PIC16C65A

Errata Sheet for Rev. B PIC16C65A Silicon

The PIC16C65A (Rev. B) parts you have received conform functionally to the PIC16C6X data sheet (DS30234C), except for the anomalies described below.

Example:

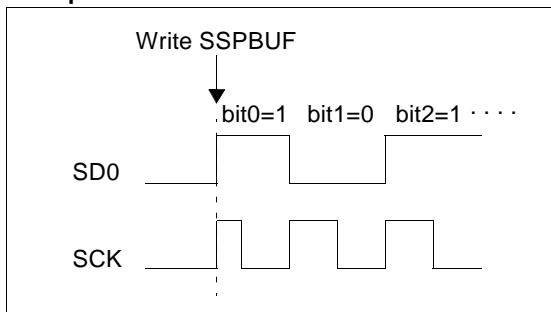
4. Module: SSP

When the SPI is using Timer2/2 as the clock source, a shorter-than-expected SCK pulse may occur on the first bit of the transmitted/received data.

To avoid producing the short pulse, turn off Timer2 and clear the TMR2 register, load the SSPBUF with the data to transmit, and then turn Timer2 back on.
